**DRAFT  
REPORT ON**

**FOUNDATION INVESTIGATION AND DESIGN  
CN RAIL OVERPASS WIDENING  
STRUCTURE SITE 3-257 (EBL)**

**DRAFT**  
HIGHWAY 417  
G.W.P. 458-98-00

Marshall Macklin Monaghan  
80 Commerce Valley Drive East  
Thornhill, Ontario  
L3T 7N4

#### 5.4.1 Axial Geotechnical Resistance

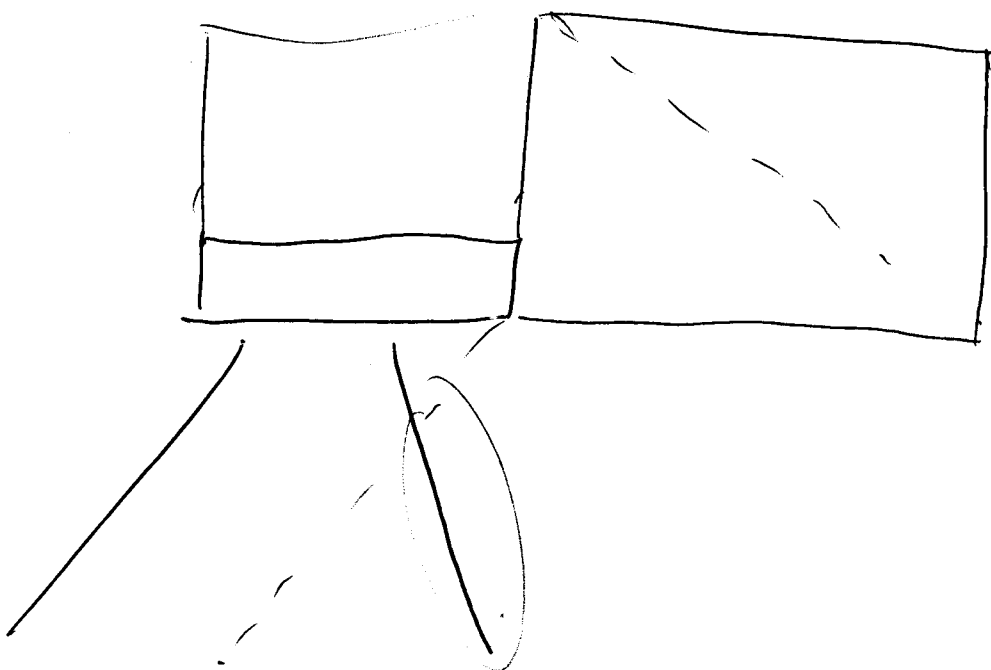
*Caisson* *anchors*  
Caissons socketted nominally (0.3 m) into the bedrock should be designed based on end-bearing resistance, and a factored geotechnical resistance at ULS of 7 MPa should be used. Serviceability Limit States resistances do not apply, since the SLS resistance for 25 mm of settlement is greater than the factored axial geotechnical resistance at ULS.

FIGURE A2

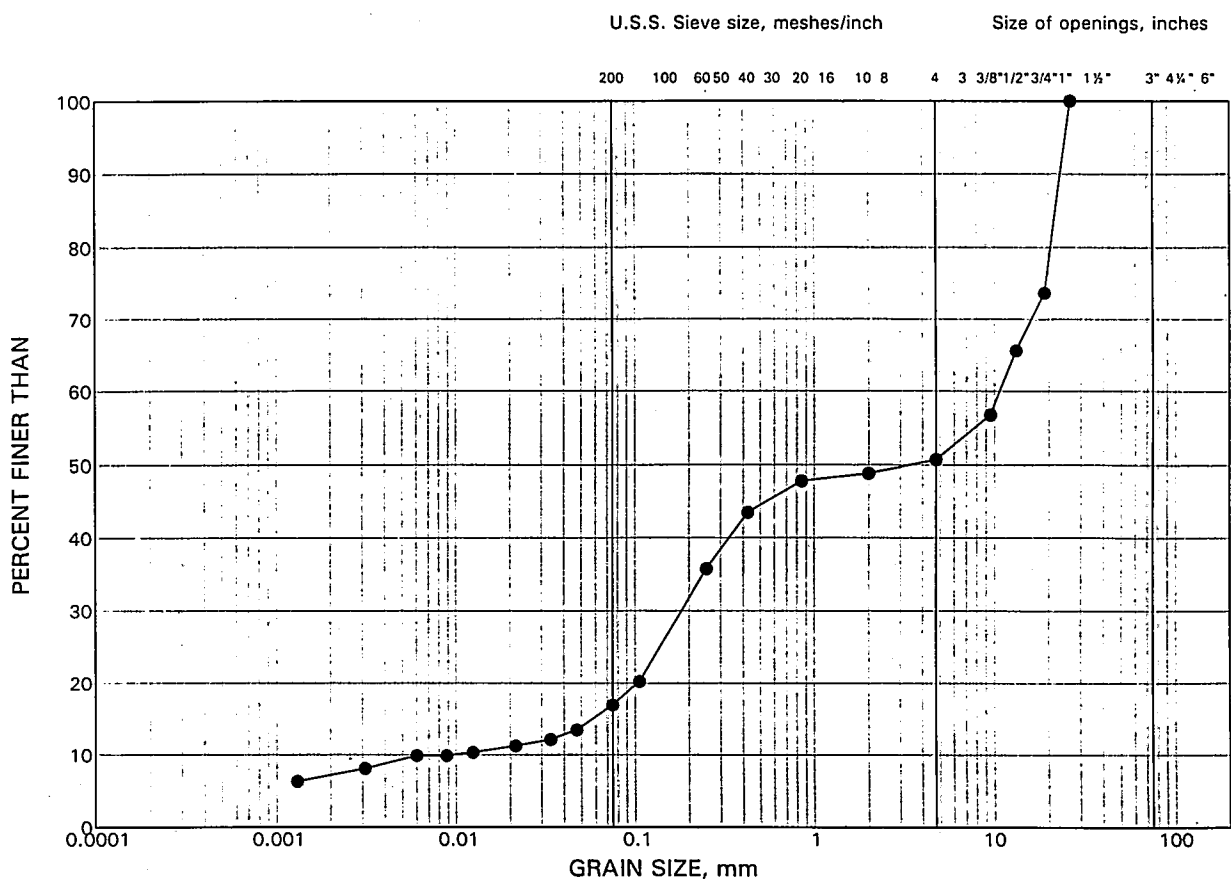
(FILL) ←
